Office Action Summary

10/595,166

PITKARY ET AL.

DETAILED ACTION

FIG. 15

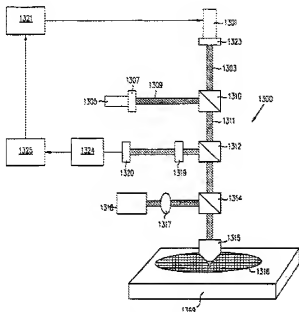
In re claim 12, Borden '791 discloses in figures 15-16 a system (1300) for testing a PCB (1316) by checking energy diffusion through board tracks comprising:

controlled heat energy source (1301, 1321) for applying heat at certain ports of the PCM (entry ports) (col. 7, lines 36-43);

thermal imaging means (1305, 1307, 1309, 1310, 1311, 1312, 1319, 1320, 1324, 1325) for measuring in time domain the rate of energy diffusion along the tracks of the board at terminating ports (col. 13, lines 40-67 to col. 14, lines 1-6);

processing means (1412, fig. 16) for comparing said measurements with prememorized values of a group of patterns that represent respective golden board results and analyzing defects automatically on the basis of learned defect test patterns (col. 8, lines 17-22).
